Project	The Falls on Refugee Road	Addendum Number	3
Project Number	23446	Date	07/10/2025
To	All Bidders

This addendum contains changes to the requirements of the bidding Documents, Project Manual and Construction Drawings which have been issued to date. Such changes are to be incorporated into the Construction Documents and shall apply to the work in the same meaning and force as if they had been included in the original documents. Wherever this Addendum modifies a portion of a paragraph of the Project Manual or a portion of any Drawing, the remainder of the paragraph or Drawing shall remain in force.

PROGRESS DRAWING NOT FOR CONSTRUCTION	05/01/2025
	23446
	C410
CD PROGRESS SET

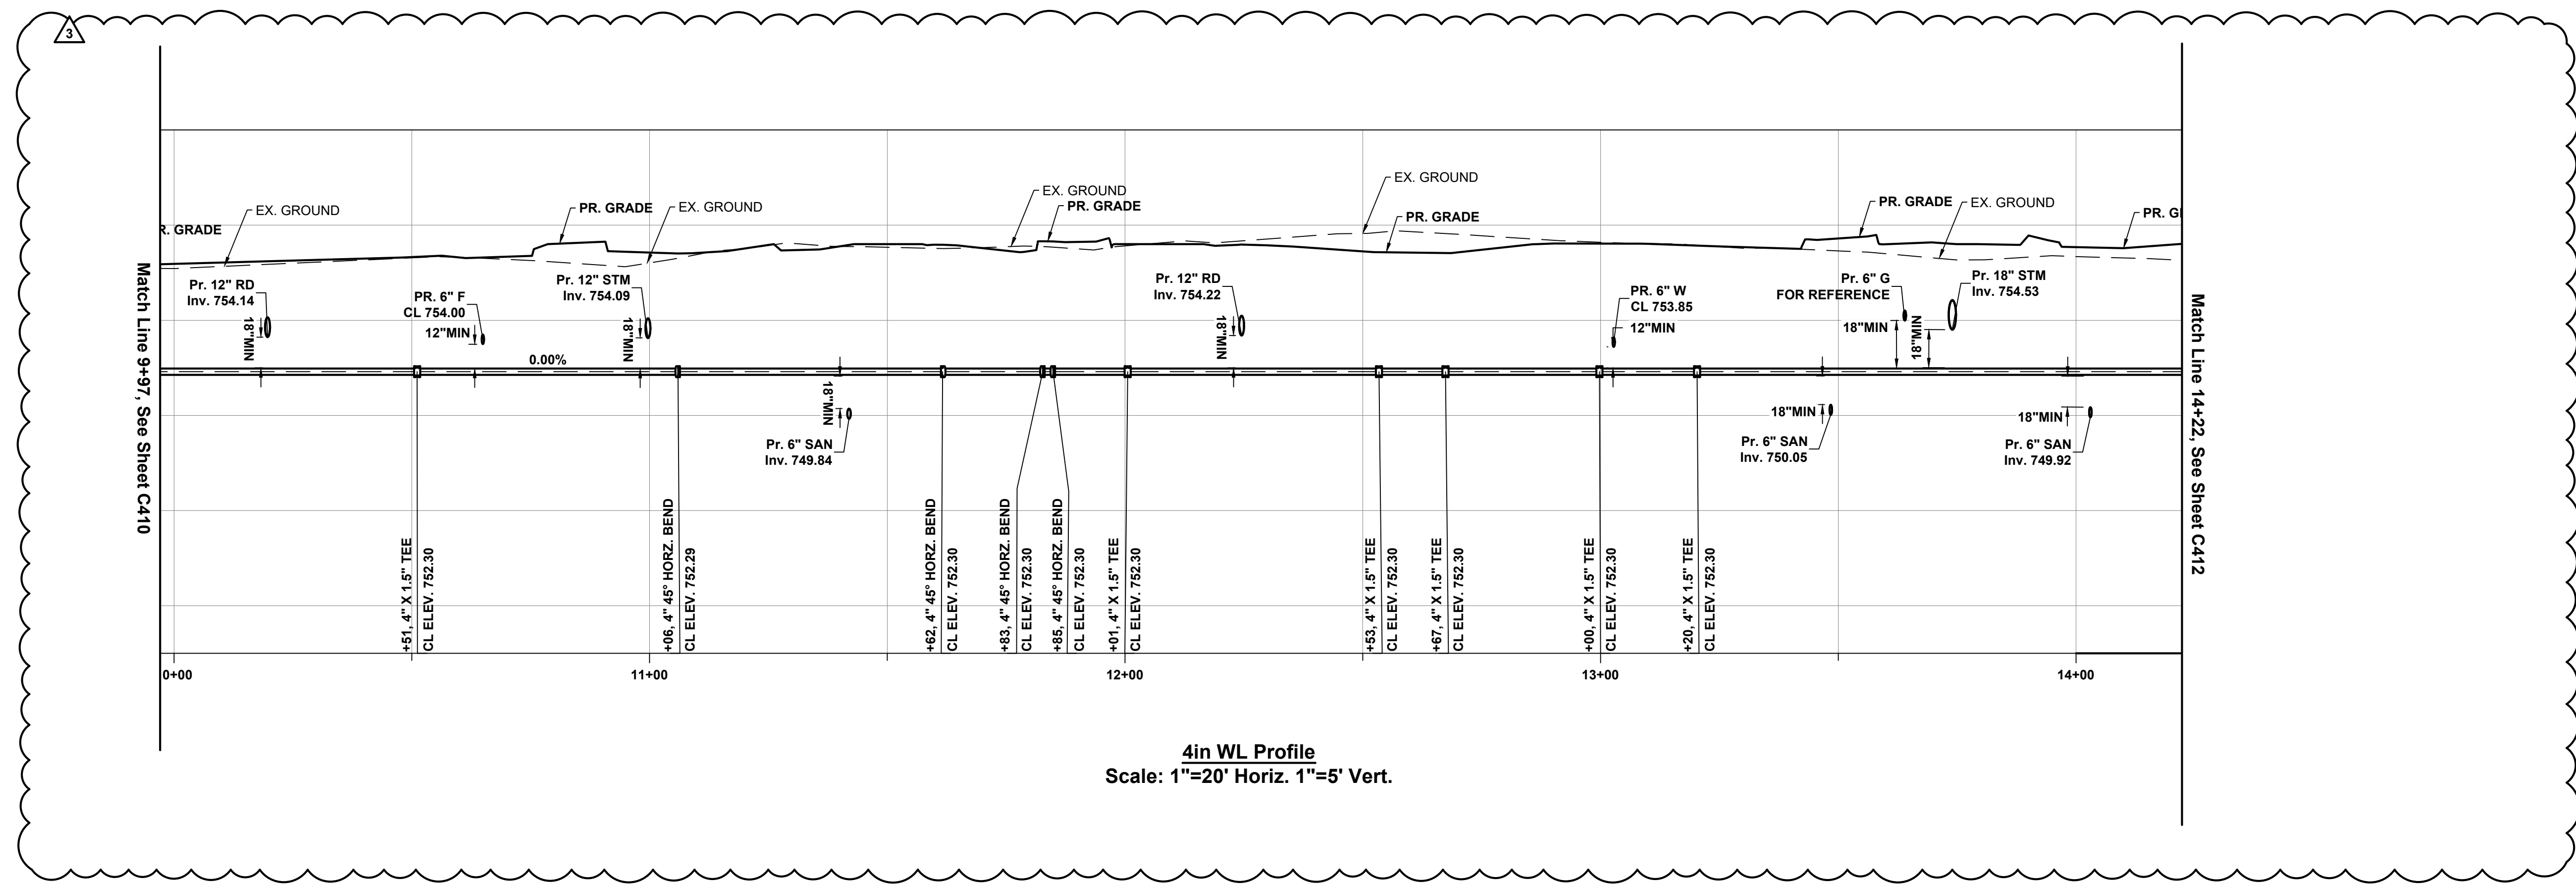
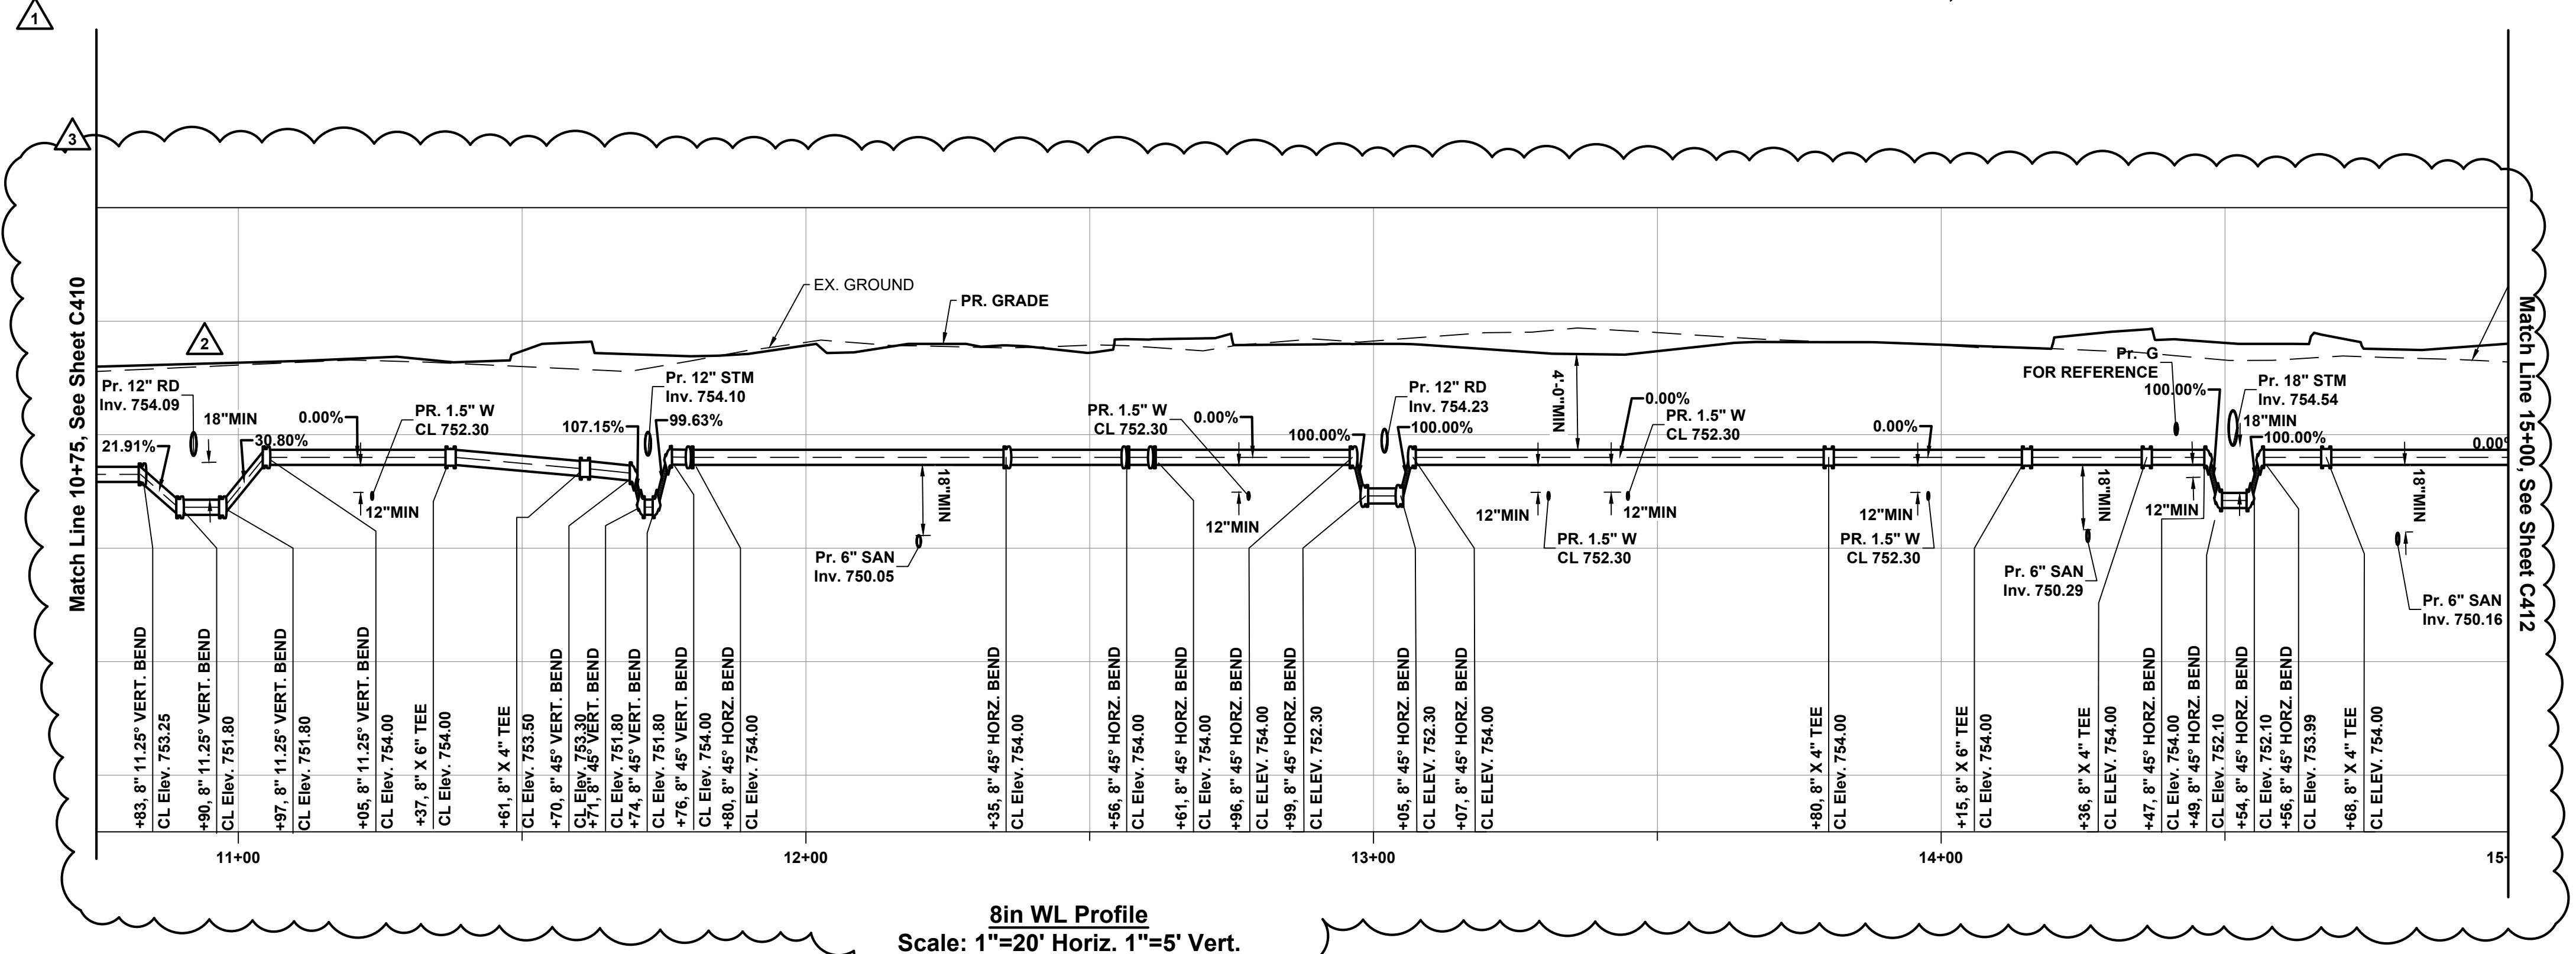
20. SHEET C410 – WATER SERVICE PLAN & PROFILE

- A. **ADD** 4in WL Profile.
- B. **REVISE** 8" fittings and service line crossings in 8in WL Profile.
